**RIVERVIEW PLANNING ADVISORY COMMITTEE**  
**STAFF REPORT**  
**Conditional Use**

**Subject :** Conditional use / Variance for multi-unit dwellings

**File number:** 23-1599

**Meeting Date:** Wednesday, December 13, 2023

SITEPLAN

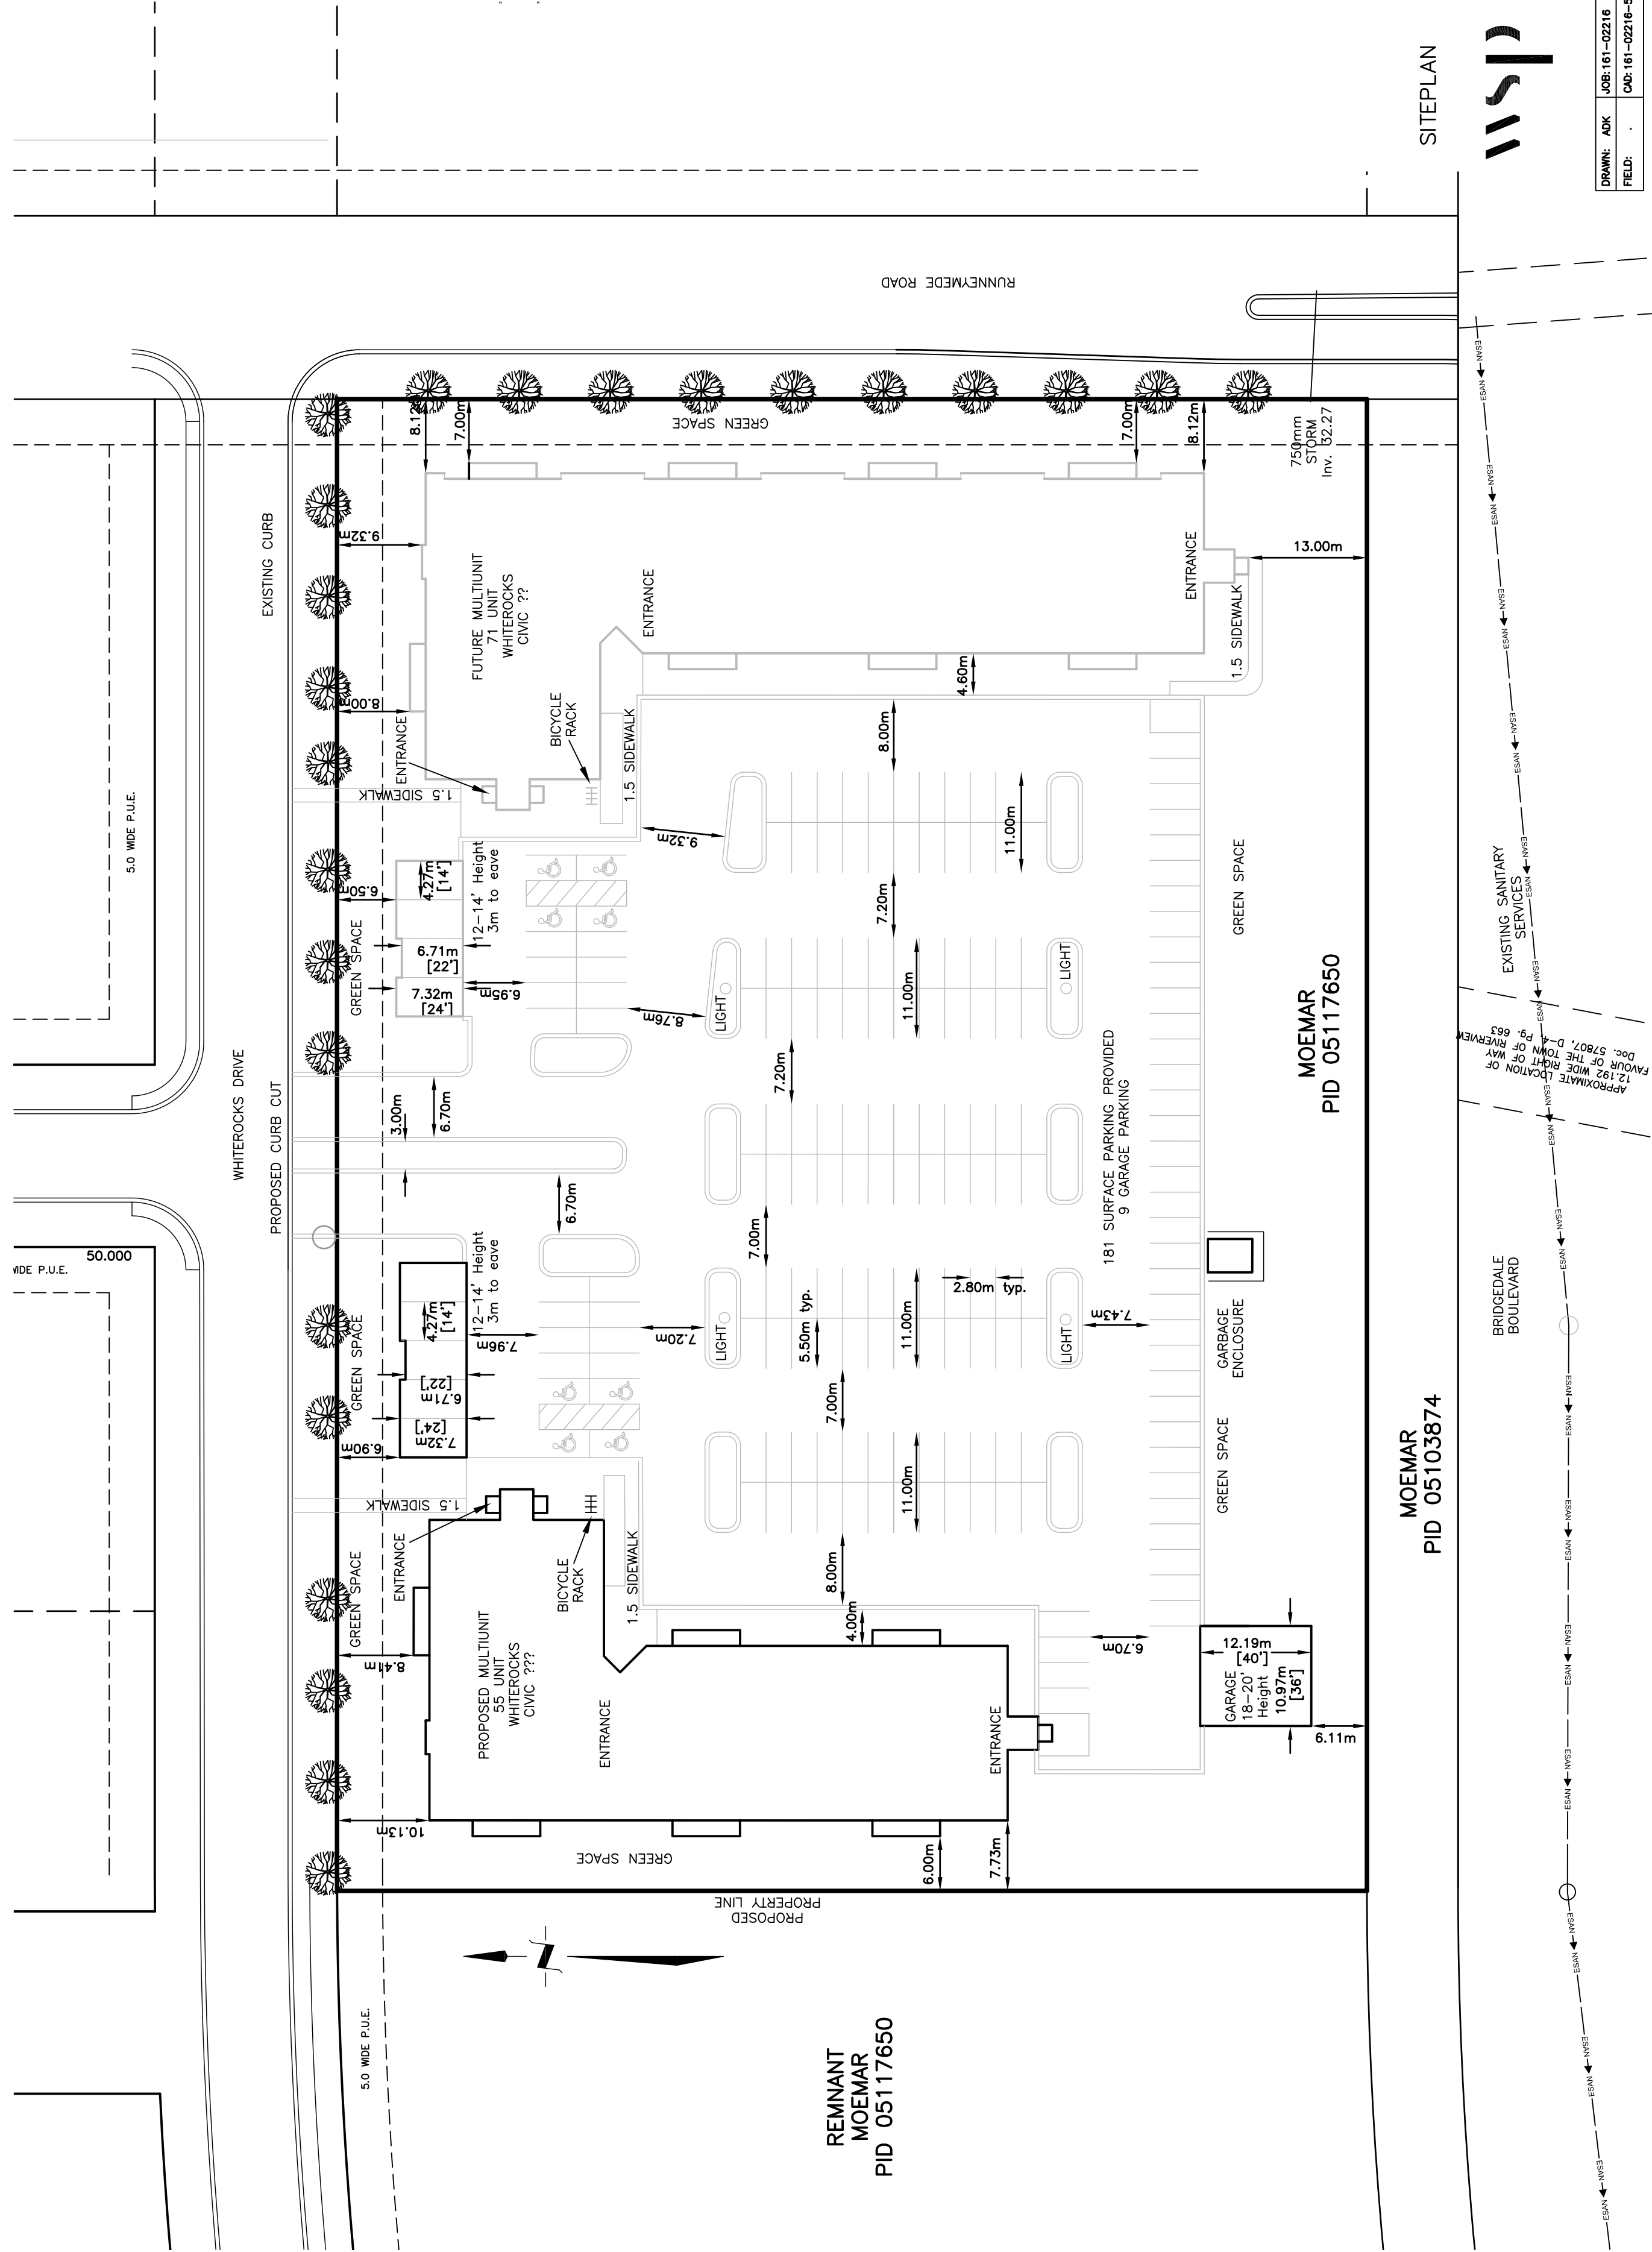
This raises the question of how best to screen the parking area from Bridgedale Blvd, which will become a main arterial road as development in the area proceeds. Members of the Development Review Committee agreed that it would be preferable to have the parking screened from the road, and that a fence is not the ideal solution. Moenar has proposed building a berm with tree planting on top as a solution. However, the details of the berm design have not yet been agreed upon with the Engineering Department, and it is not yet certain this will be an acceptable solution. As such, staff is comfortable leaving this aspect unaddressed for this approval, with the understanding that an acceptable solution be submitted at the time of the building permit application. The appropriate solution will need to be acceptable to the development officer and Town administration prior to issuance of a building permit.

1) That the developer propose appropriate landscaping and screening between the property and Bridgedale Boulevard so as to screen the parking area from the public right-of-way;

REAR ELEVATION

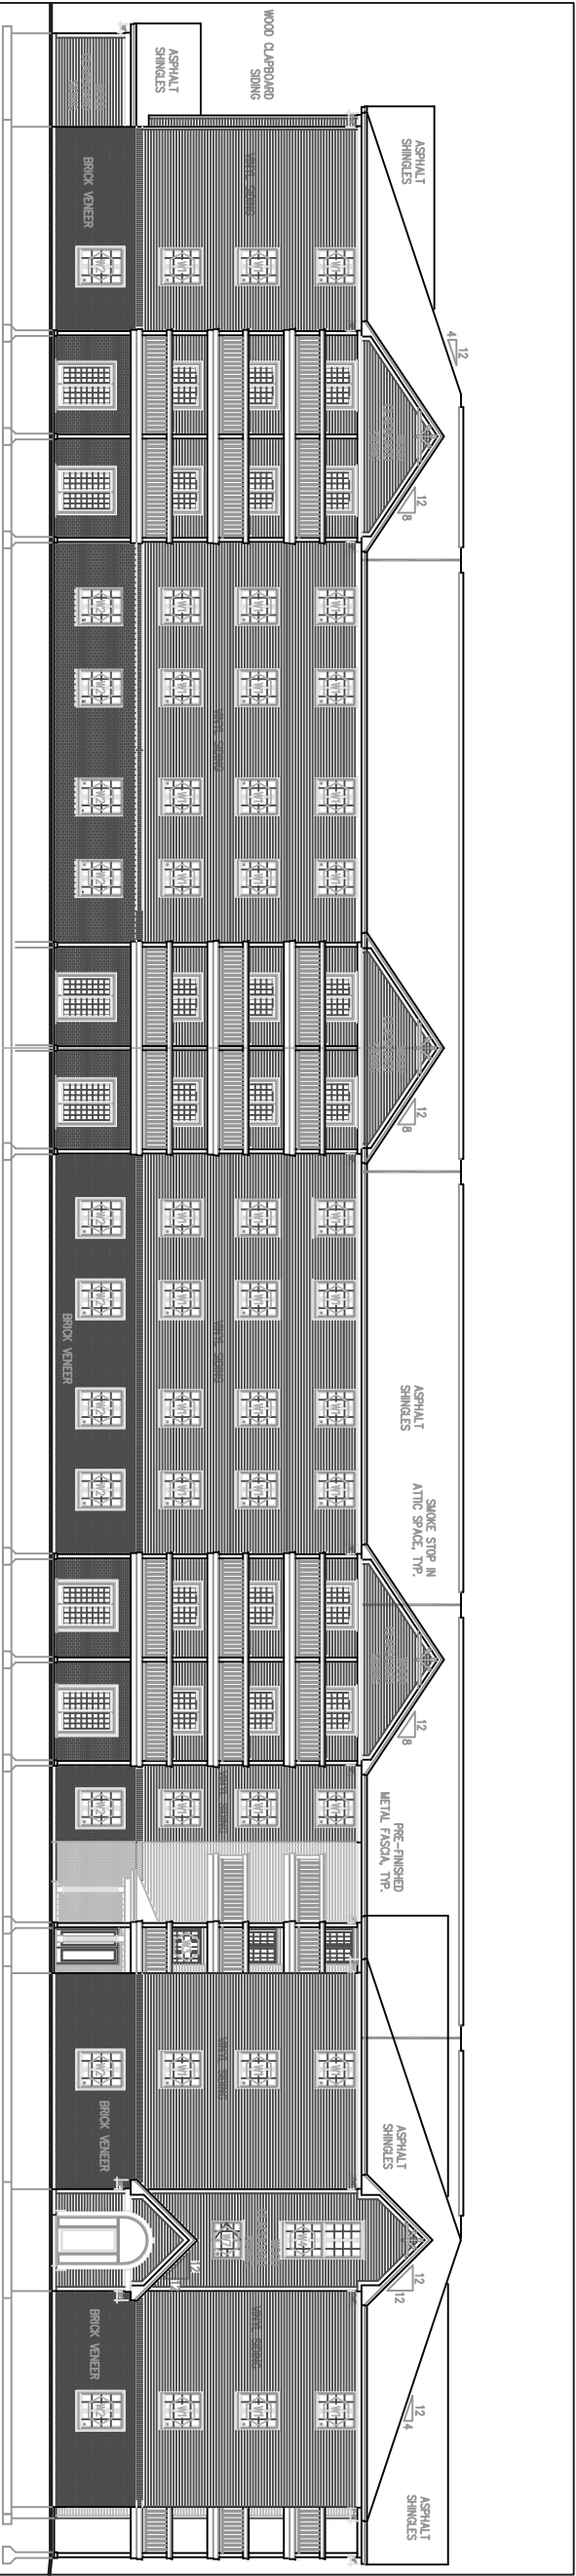
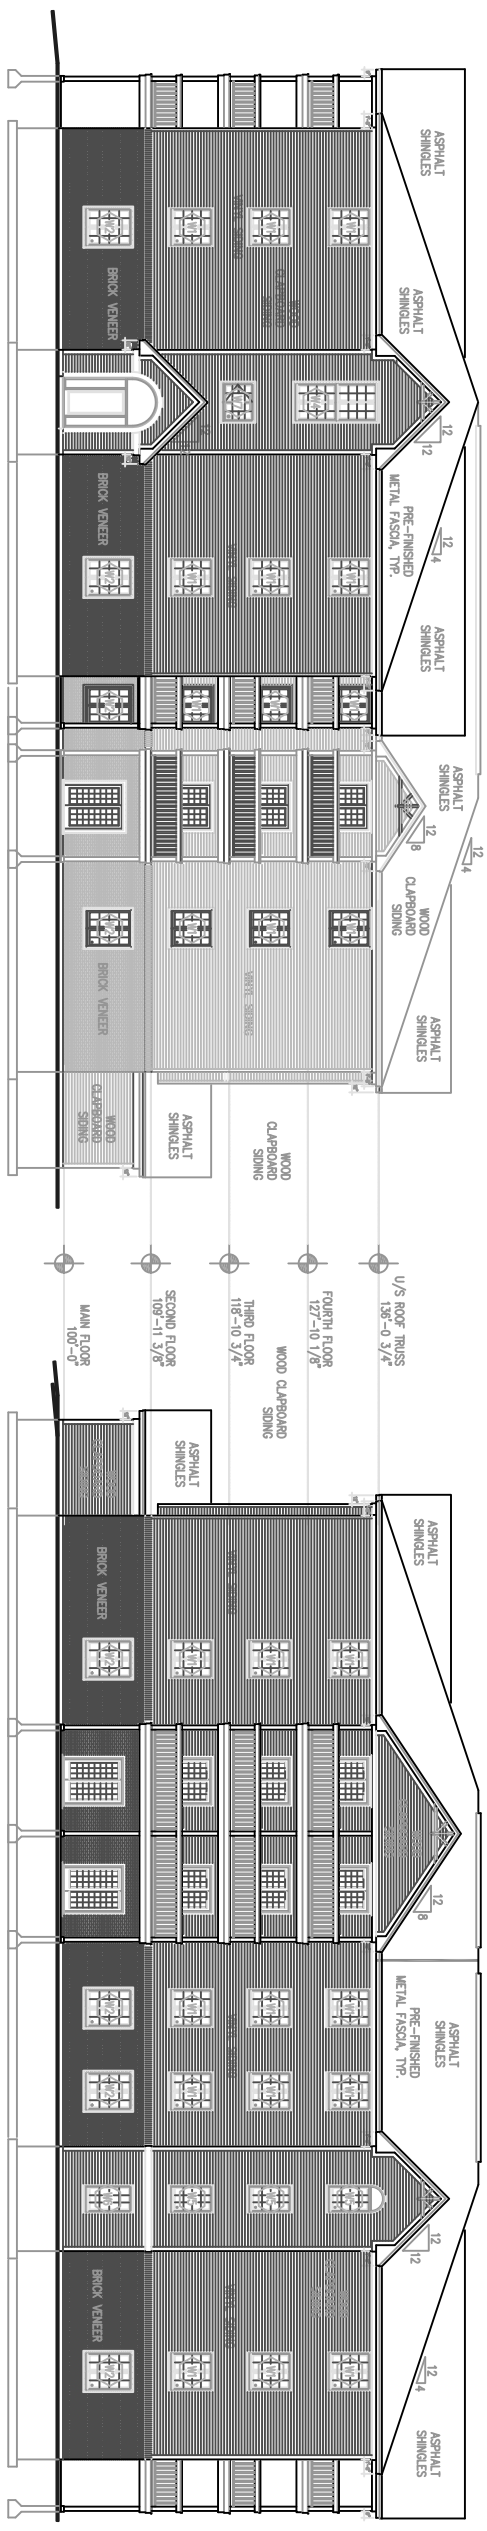
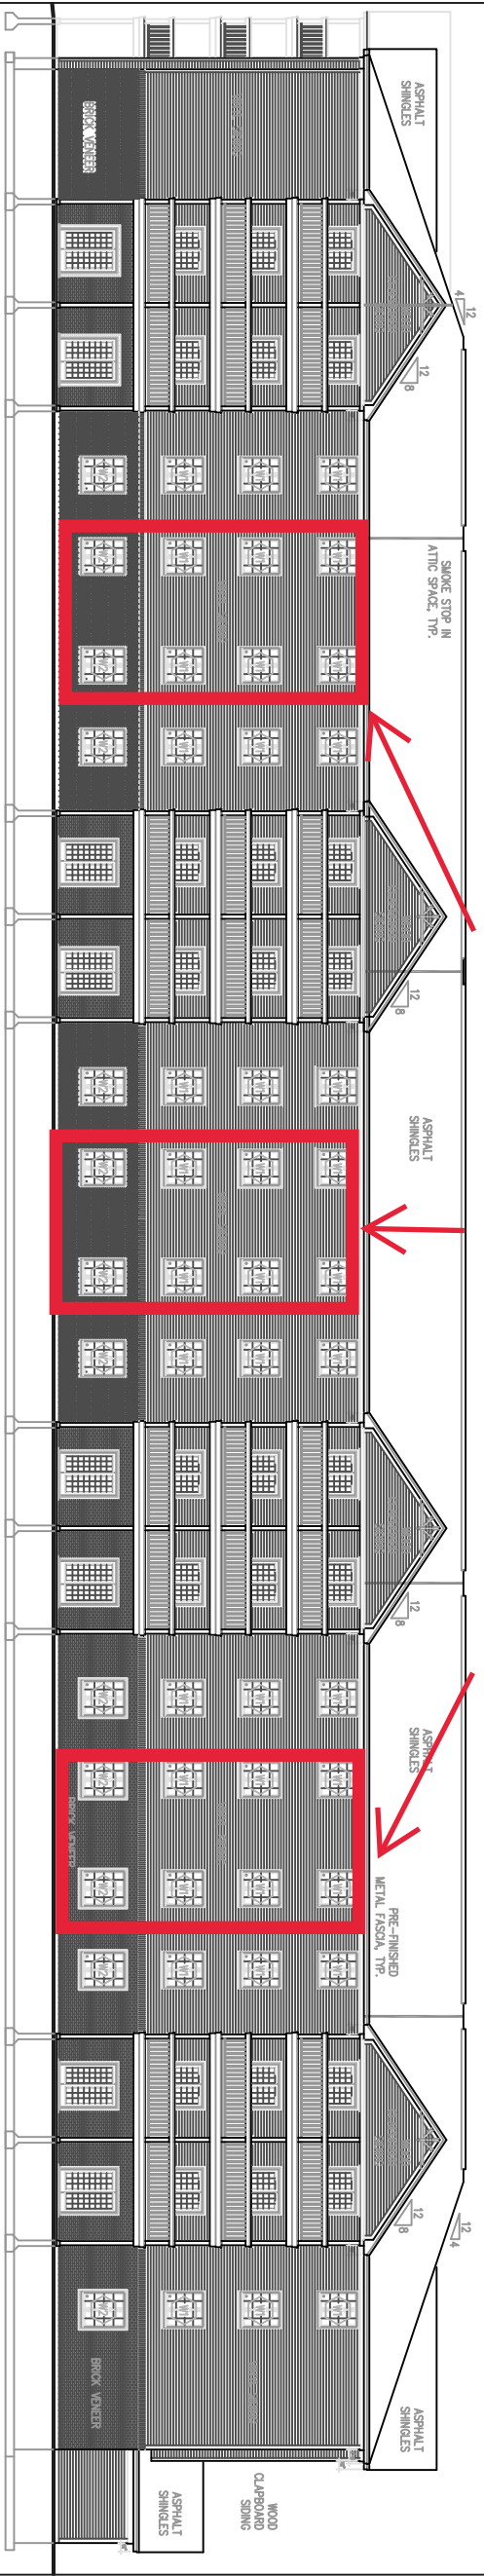
Jogs and recesses to be incorporated along facade

A-1

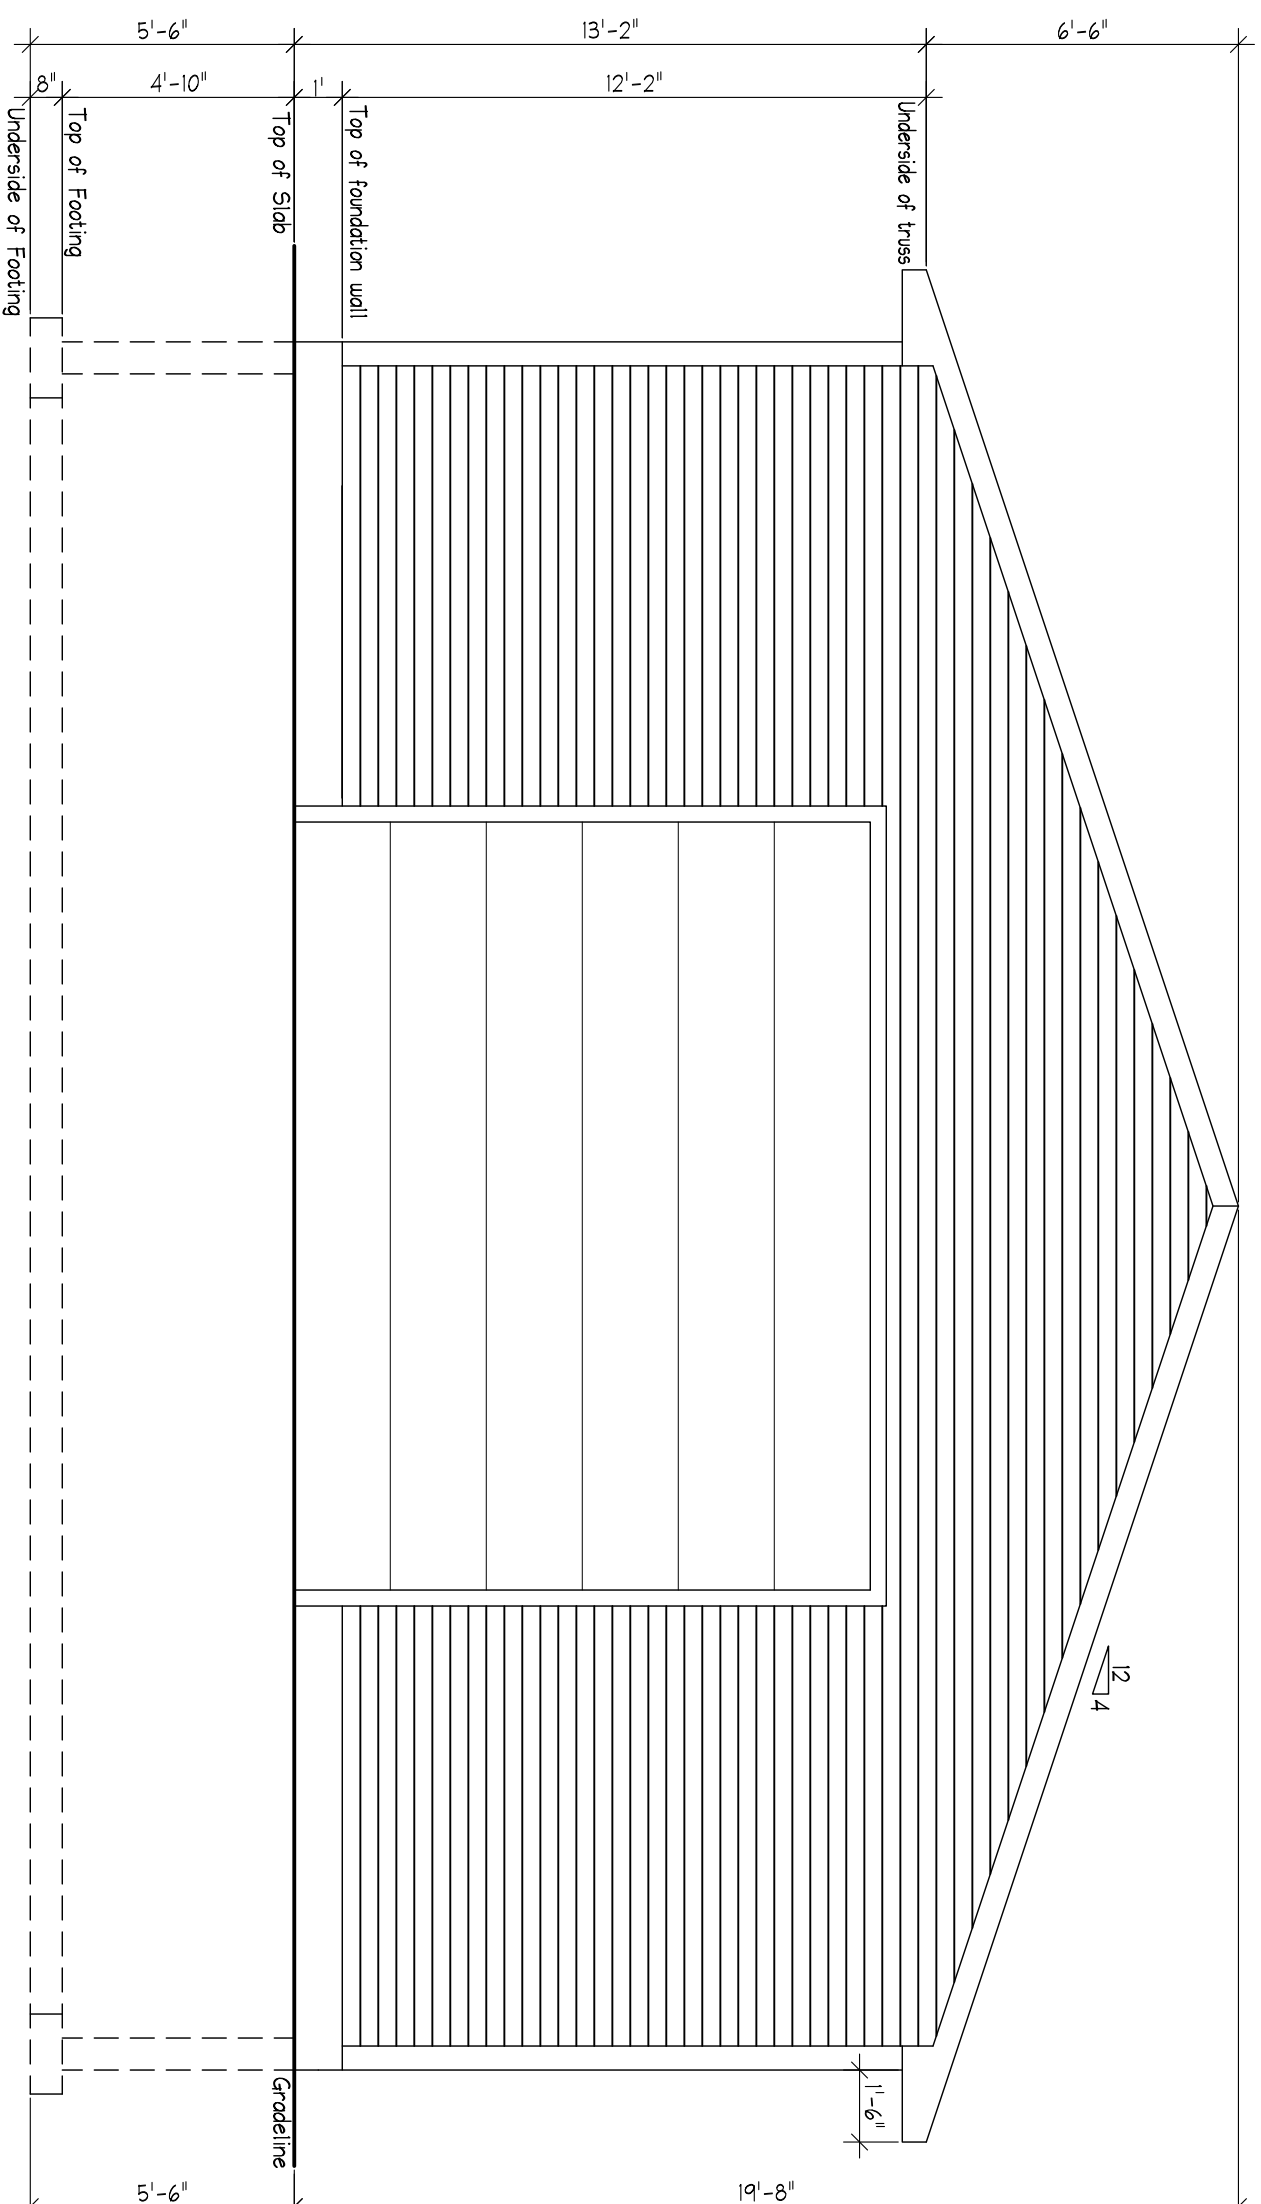
The developer plans to include two single storey storage garages at the parking entrances in order to limit the visual impact of the parking area from Whiterocks Dr. These buildings will incorporate windows and cultured stone facing the street in order to fit the surrounding aesthetic. A third accessory building is proposed to the rear of the property. Per the Zoning By-law, the height of accessory buildings is measured from the established grade to the underside of the eaves in the case of a gable roof. In a residential zone, a height of 3m is permitted for a gable roof, with a maximum of 6m total building height. The developer is requesting a variance to permit a height of 4m in order to accommodate a 10' door which will allow for access to larger vehicles for the on-site storage of salt for winter maintenance. Given that the 6m height maximum is still being met, and the accessory building is not abutting an adjacent property, staff feels the request is reasonable.

1) APPROVE the variance to increase the height of an accessory building from 3 metres to 4 metres to the underside of the eaves with a maximum building height of 6 metres because the proposed building will not negatively impact any adjacent properties and meets the general intent of the Municipal Plan and Zoning By-law
